**PETITIONER'S RESPONSE TO LAND USE COMMITTEE QUESTIONS
FROM OCTOBER 28, 2014 PUBLIC HEARING CONTINUATION**

Dated: November 6, 2014

NEWTON, MA

THE RESIDENCES AT
KESSELER WOODS

UTILITY PLAN

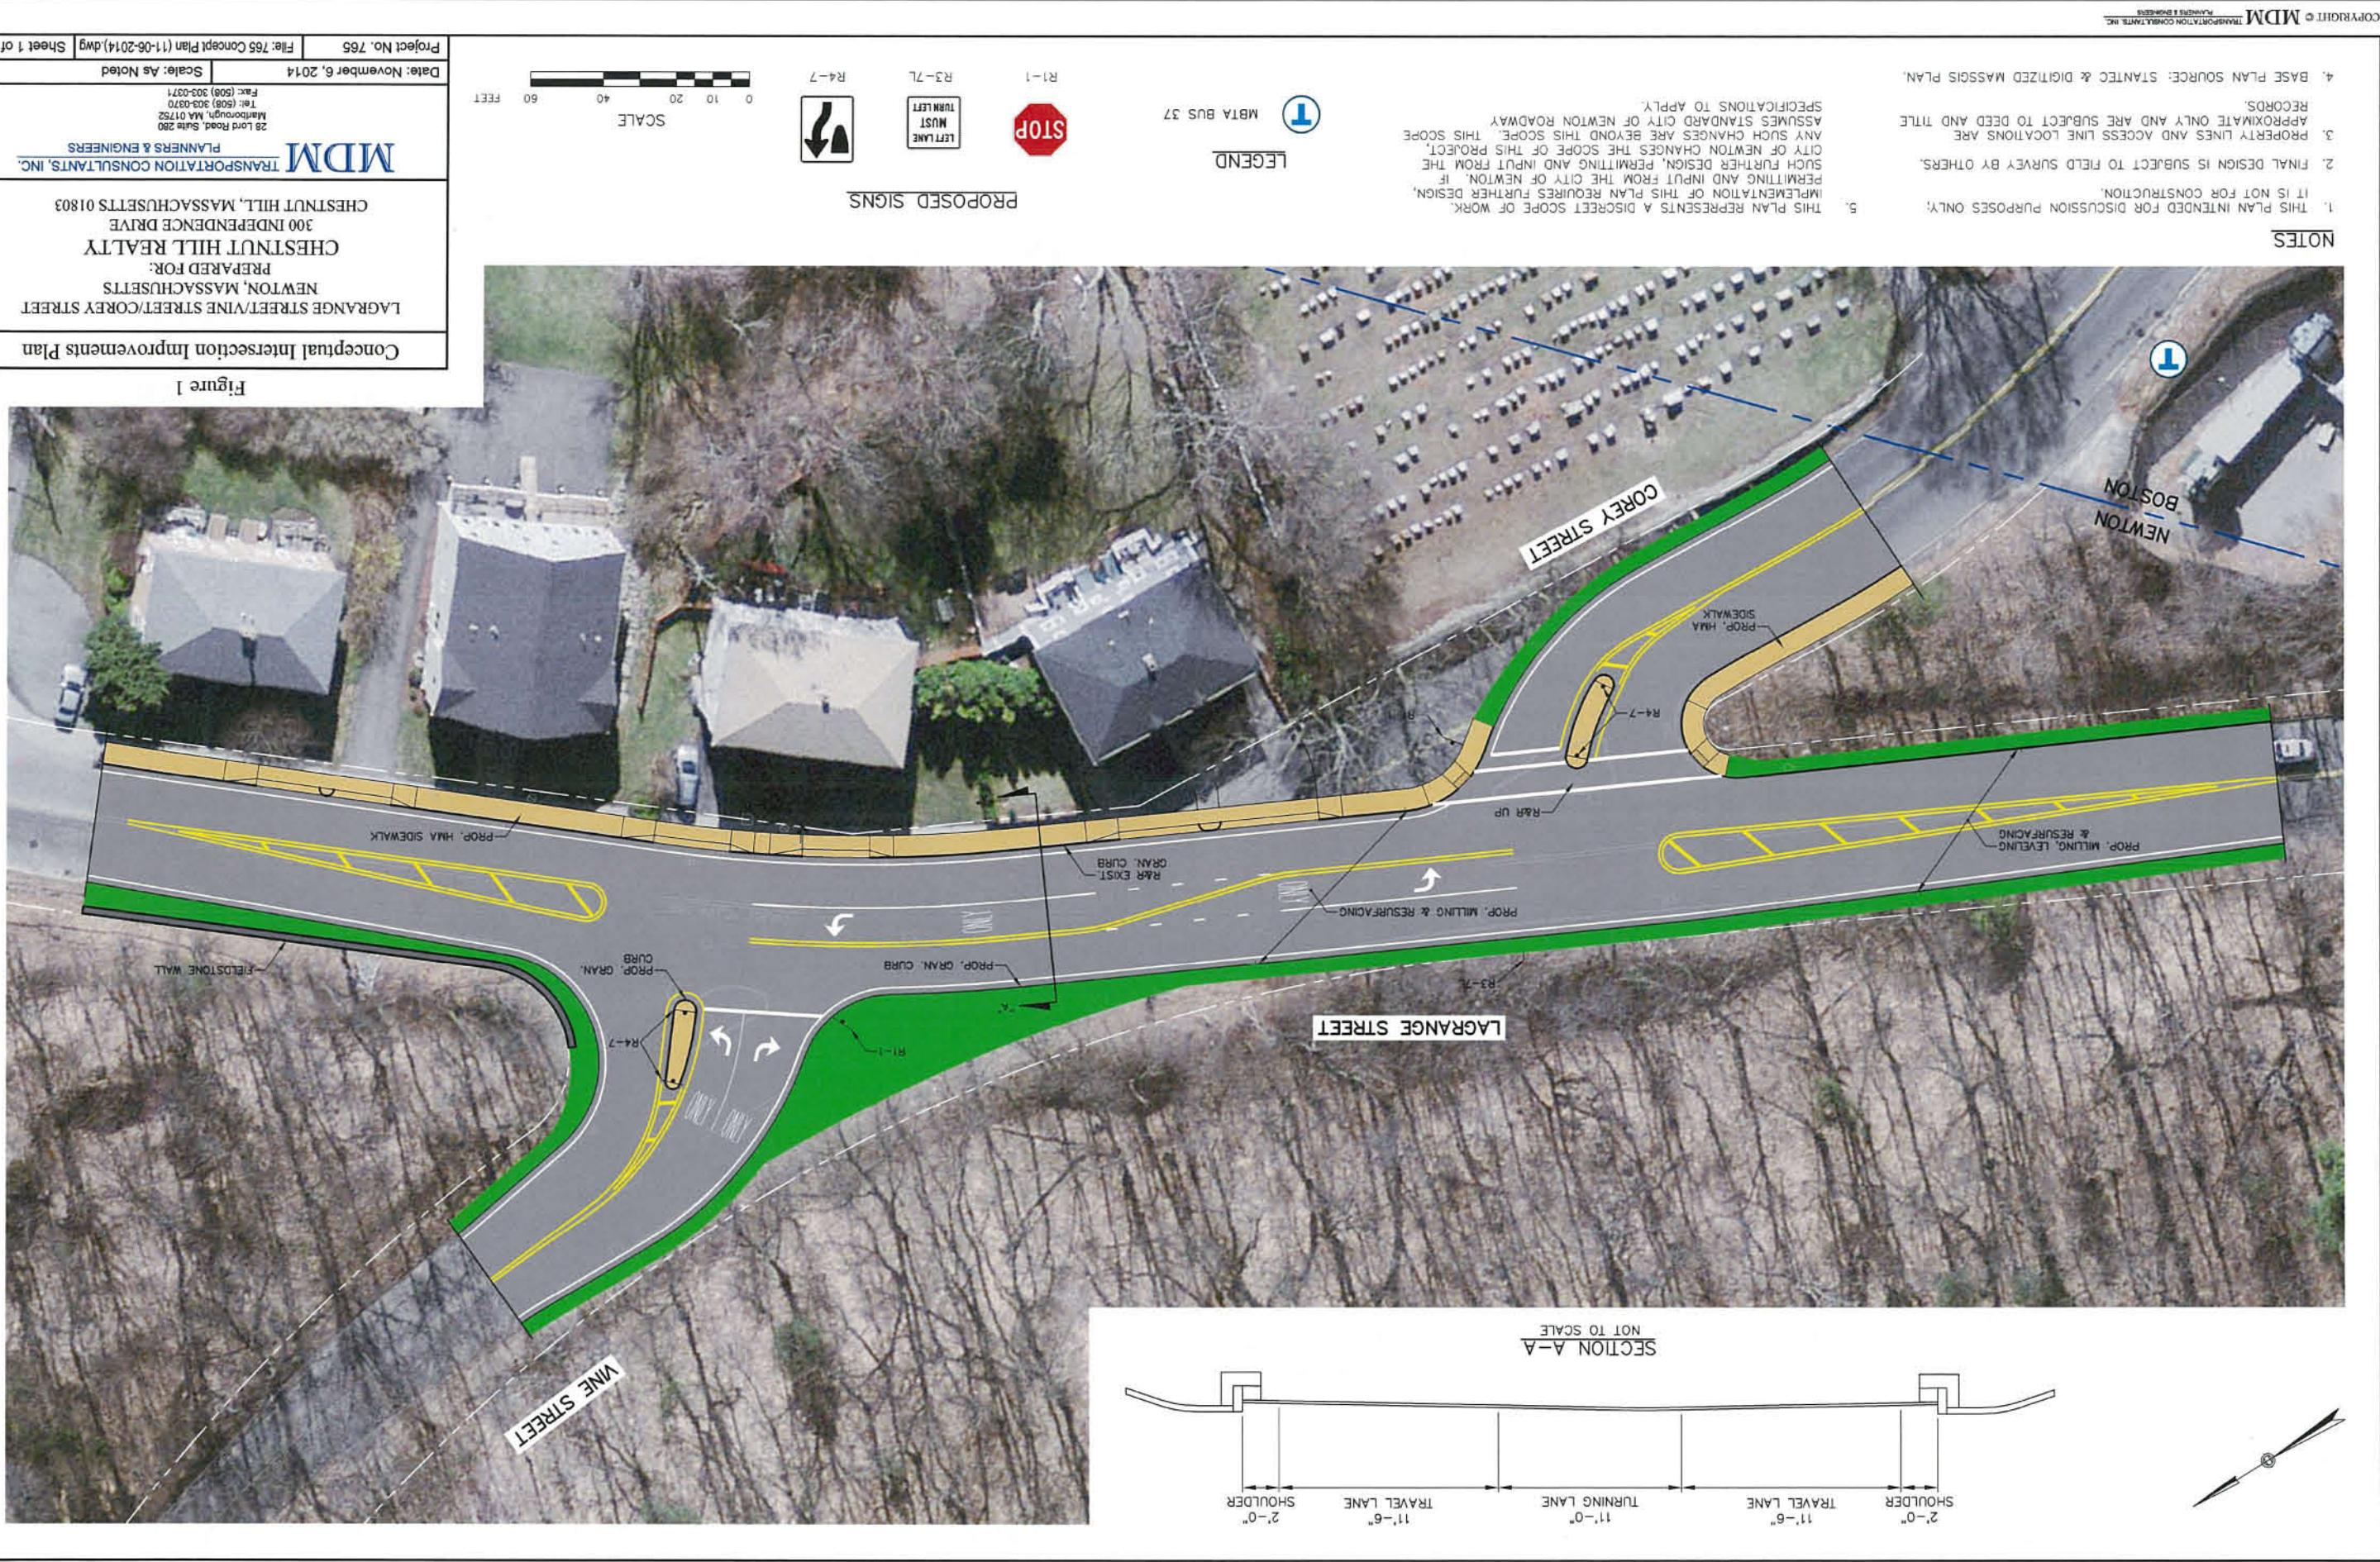
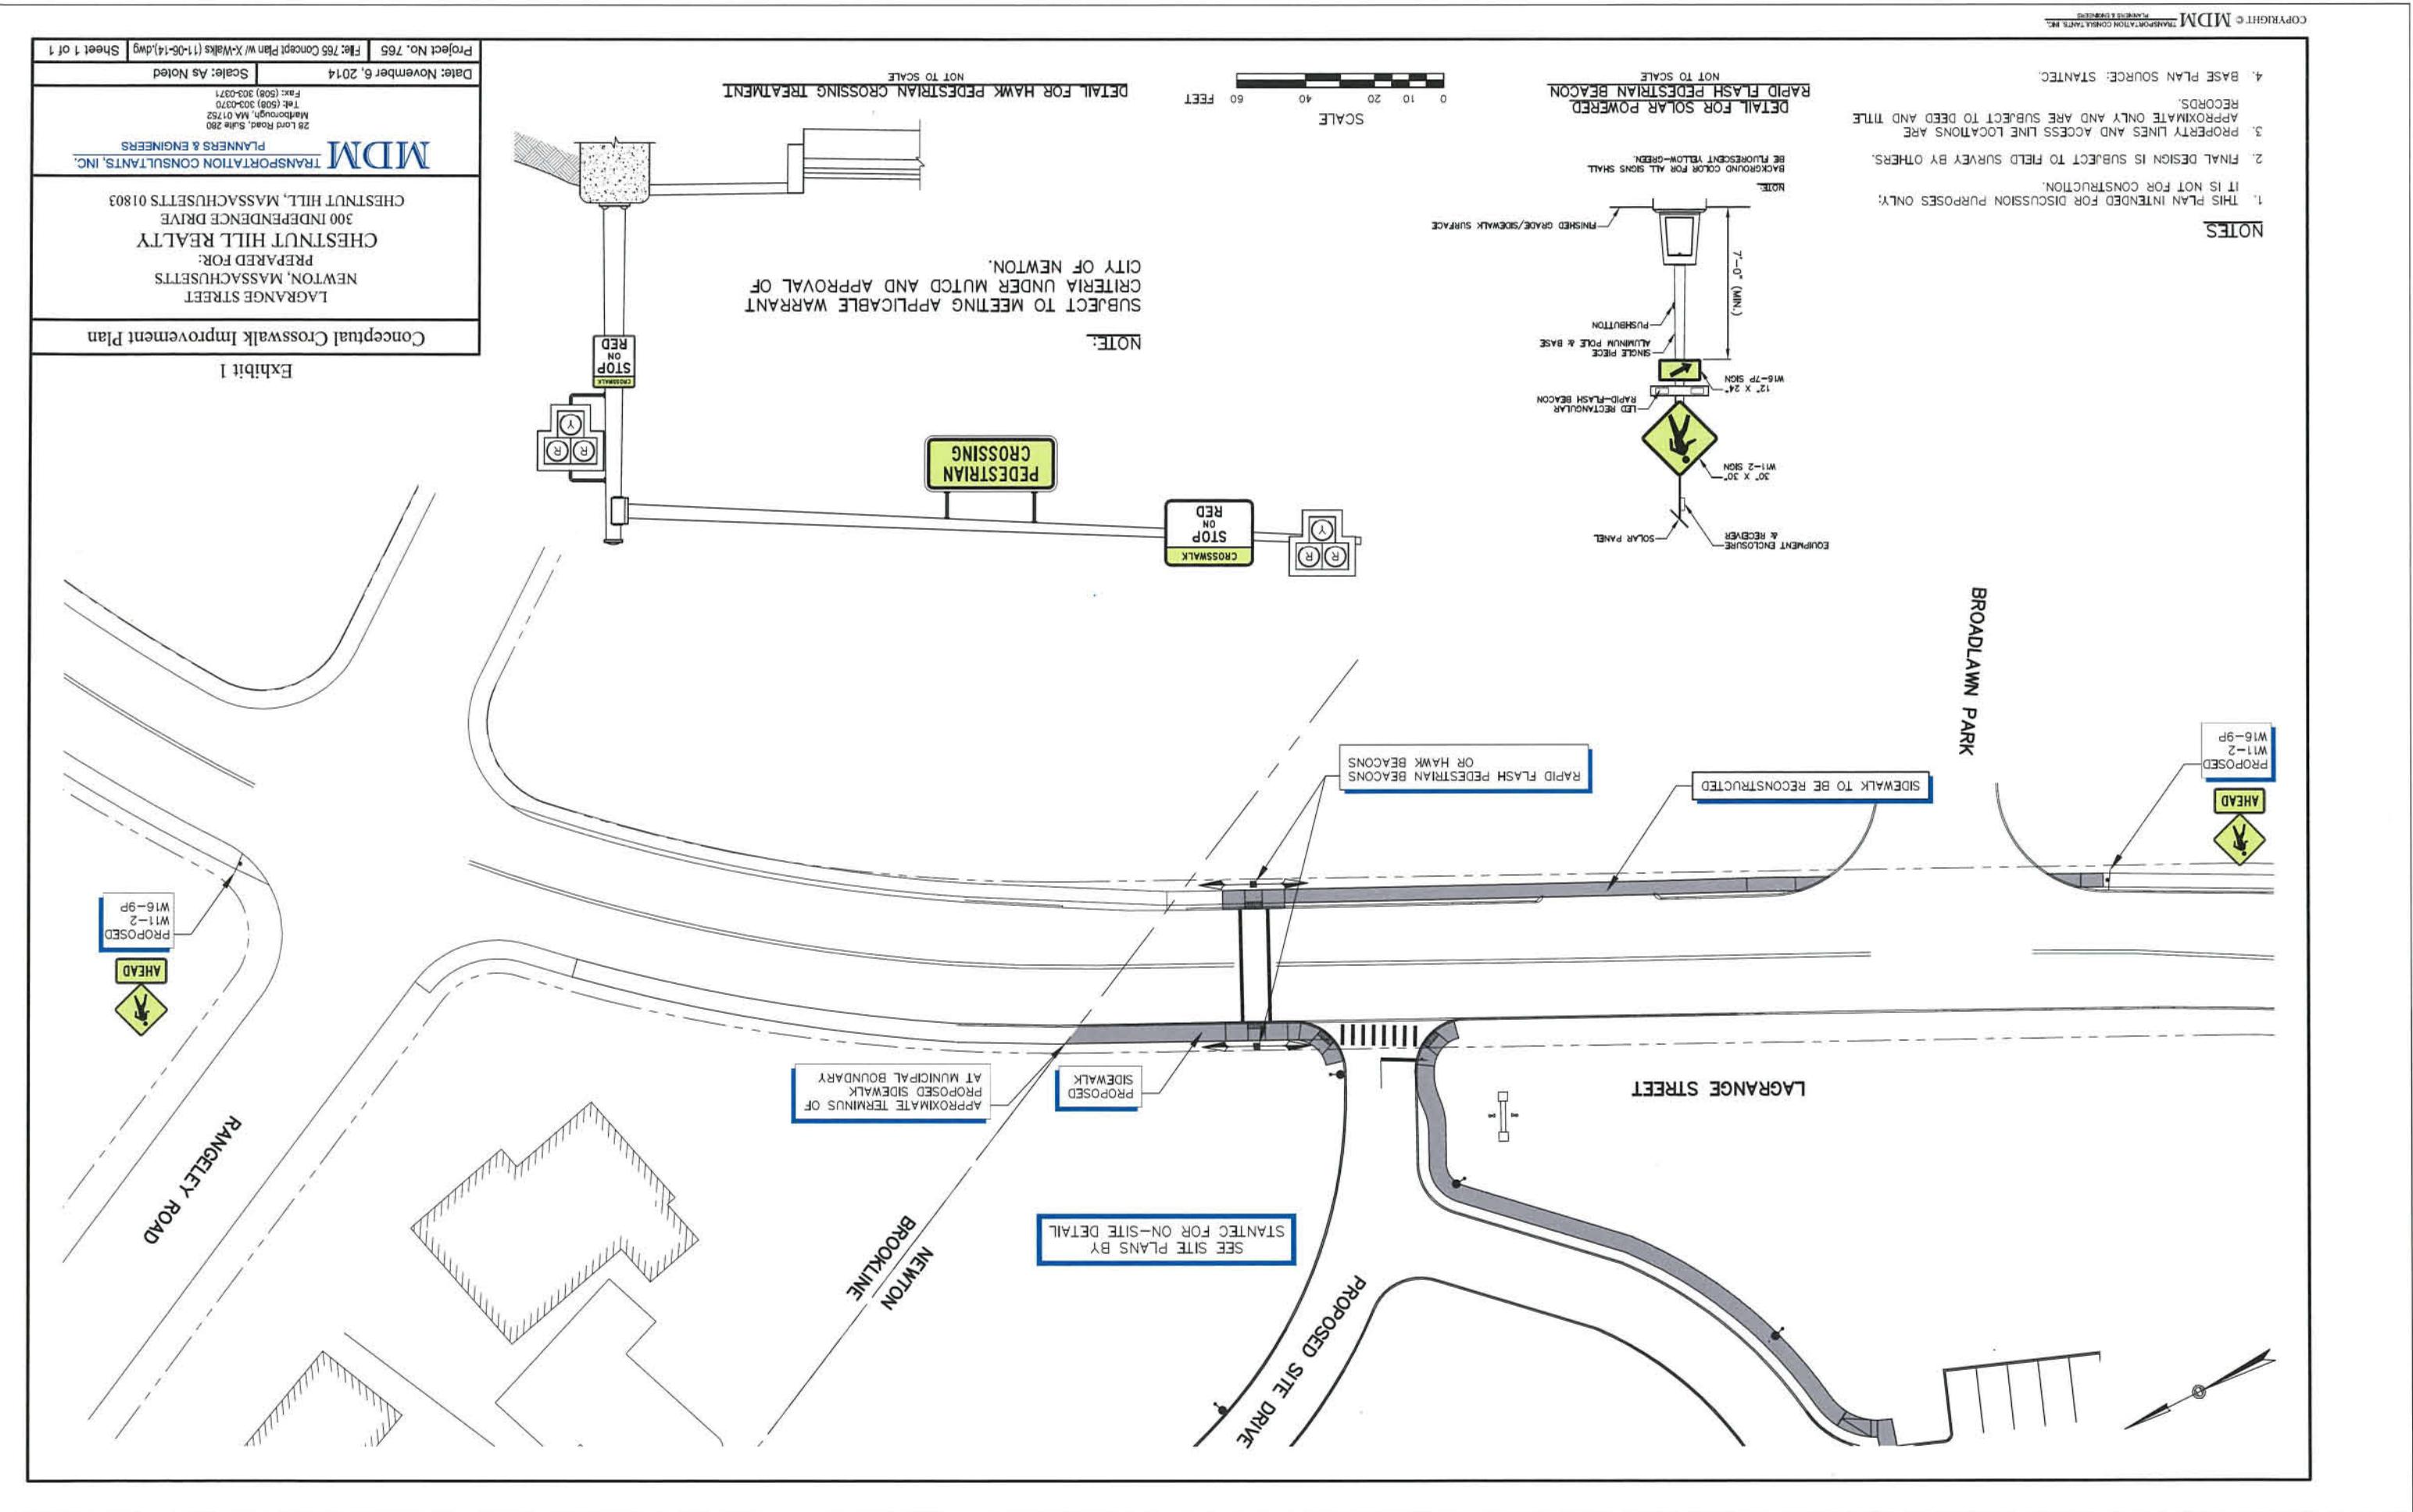
Following consultation with the City Engineering Department, the revised plans (L-300 and L-301) dated November 6, 2014 reflect relocation of the water main extension from the private property to LaGrange Street. This will eliminate the need for any easement to the city. The Petitioner understands this location is preferred by the Engineering Department. The Plans also show the sewer connection location in LaGrange Street above the existing culvert. This too is the recommended connection location by the Engineering Department. Per our discussion including Engineering these updated plans add the additional requirements from Engineering and the full details of these utilities will be a building permit condition.

Figure 1 - Particle Velocity Vs Frequency
United States Bureau of Mines (1980)

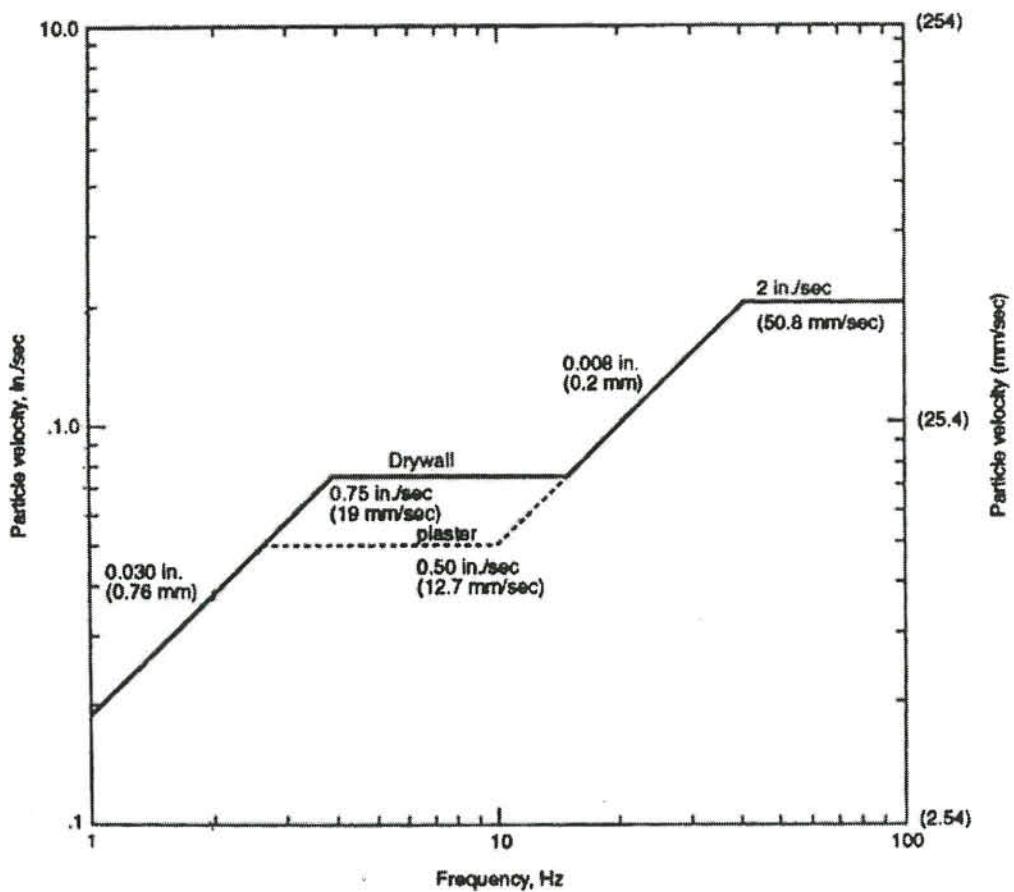
- a. Maximum blast induced ground vibrations at the nearest adjacent above ground structure to blasting should be kept below the U.S. Bureau of Mines recommended Safe Limits, as indicated on Figure 1. These limits are based on the frequency and peak particle velocity of the blast vibrations and are safe limits for preventing
